Name of Project: EM and Thunderbird- Fast Food Restaurant Acreage: 2.19  
 Property Address/Location: SE Corner of N El Mirage Road and W Thunderbird Road  
 Assessor's Parcel Number: 501-36-283G

# **RALLY'S RESTAURANT**

**COMMENT RESPONSE LETTER FOR  
FAST FOOD RESTAURANT- ELM & THUNDERBIRD**

<b>Current Submittal:</b>	Development Application	<b>Project Name:</b>	Fast Food Restaurant- ELM & Thunderbird
<b>City of El Mirage No.</b>	PZ22-01-01	<b>Project No.</b>	21004
<b>City of El Mirage:</b>	<b>Jose A. Macias</b> Senior Planner Development Services – Planning & Zoning   GIS <a href="mailto:jmacias@elmirageaz.gov">jmacias@elmirageaz.gov</a> 623-876-2996 PH 623.876.4605 FAX	<b>Designer:</b>	Hauser Engineering Group PO Box 6207 Glendale, AZ 85312 (623) 322-0567 Attn: Chris Hauser
<b>Action Codes</b>	A= Will Comply                      B= Designer/Consultant to Evaluate C= City to Evaluate                  D= Disregard Comment

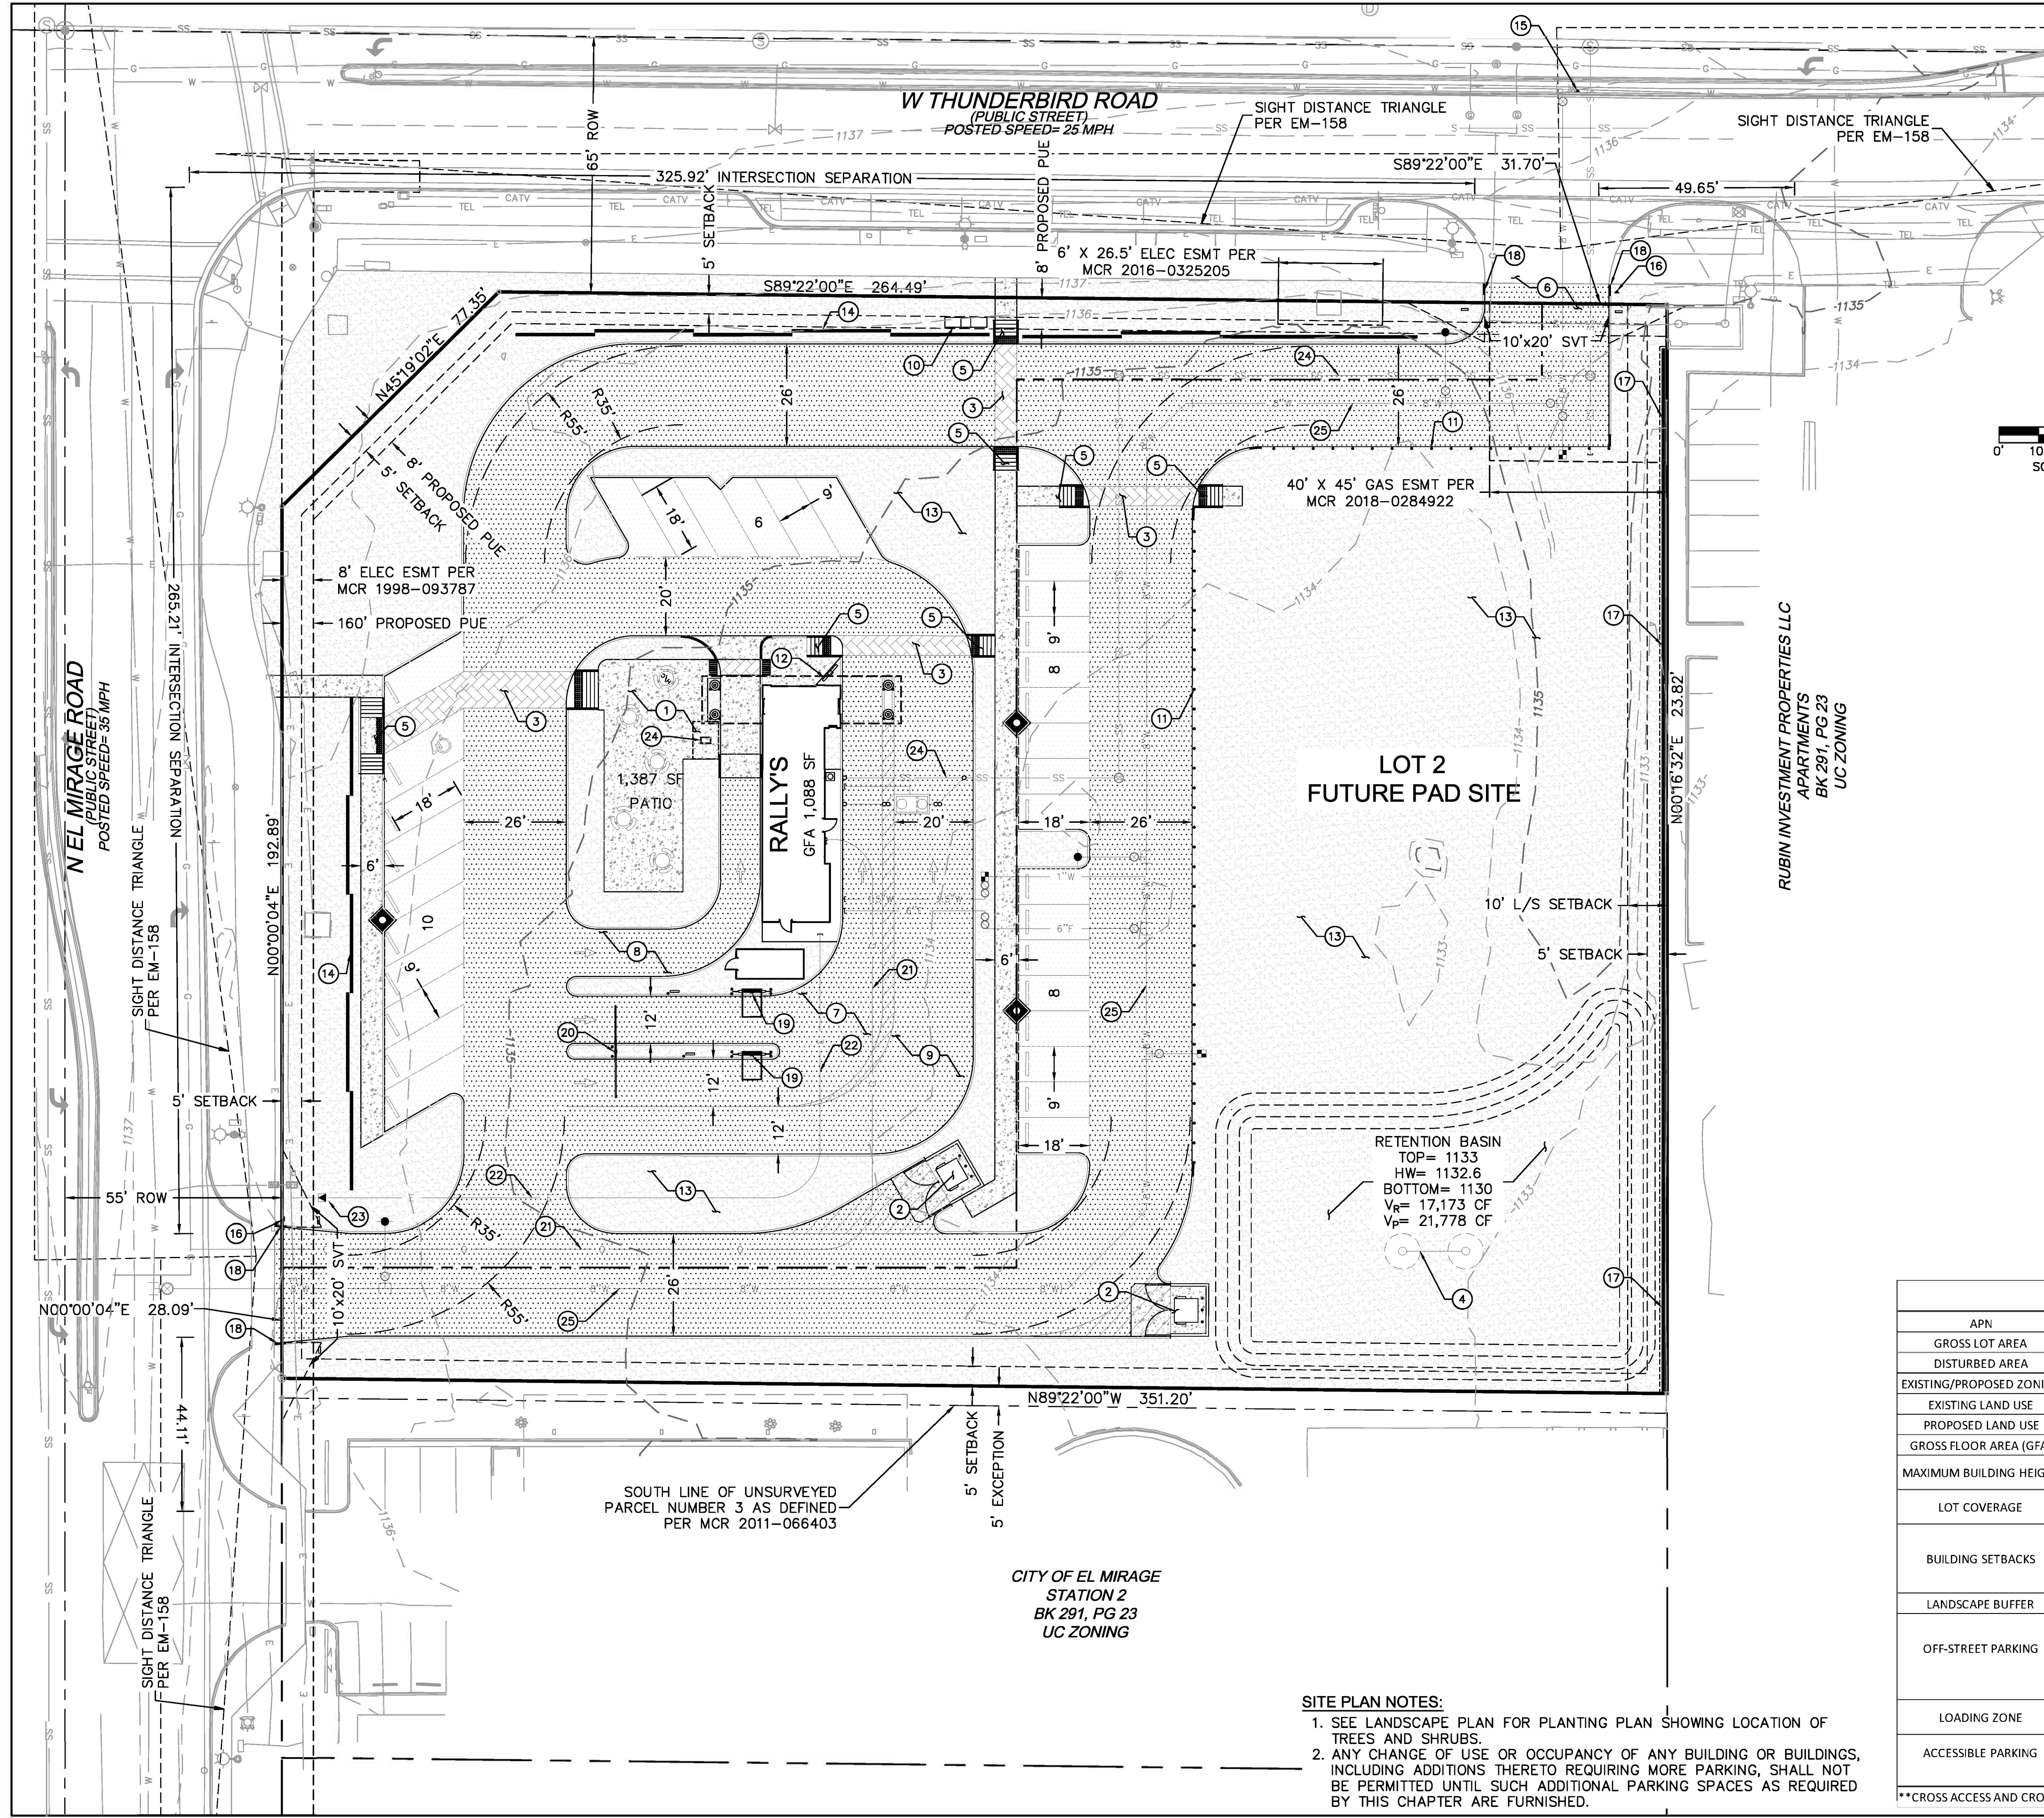
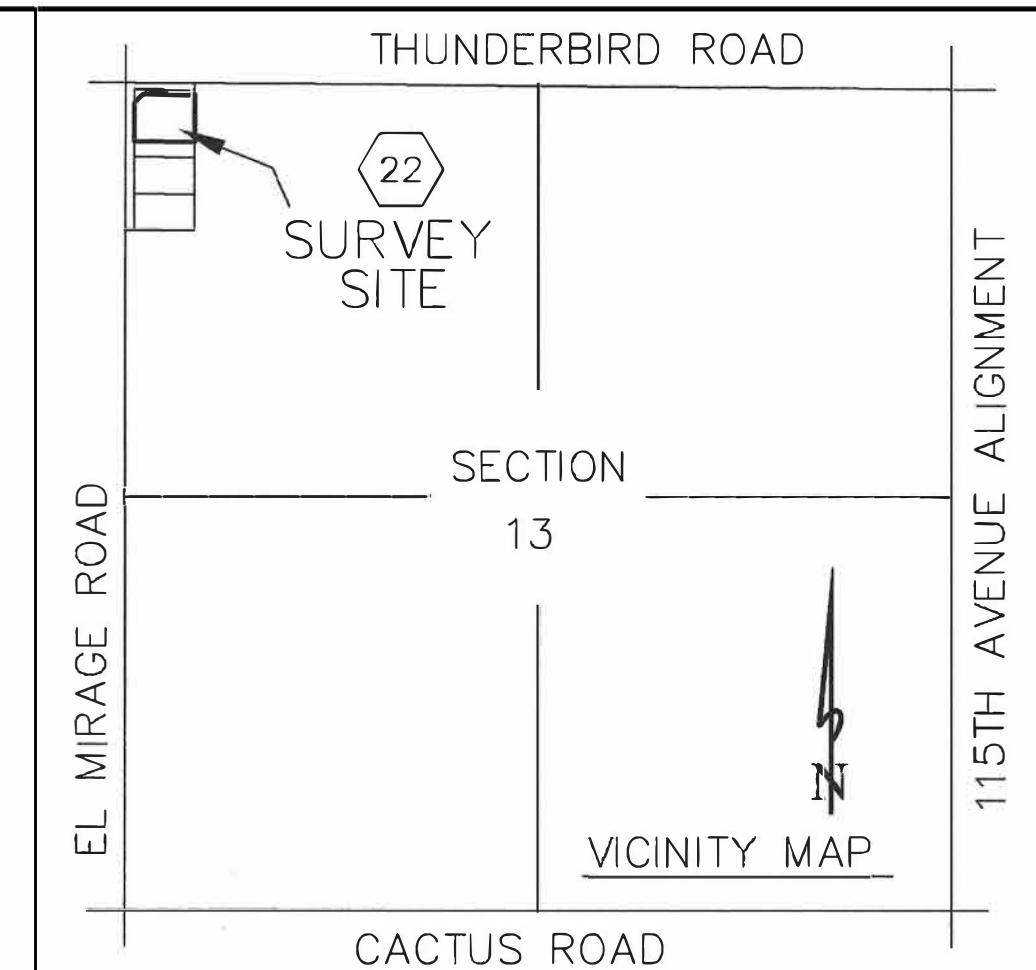
<b>Exterior Elevations</b>					
<b>Bryce Christo</b> Assistant City Engineer <a href="mailto:bchristo@elmirageaz.gov">bchristo@elmirageaz.gov</a> 623-876-2974 PH	27		Provide a description of exterior materials to be used.	A	Please see the revised elevations, which include more
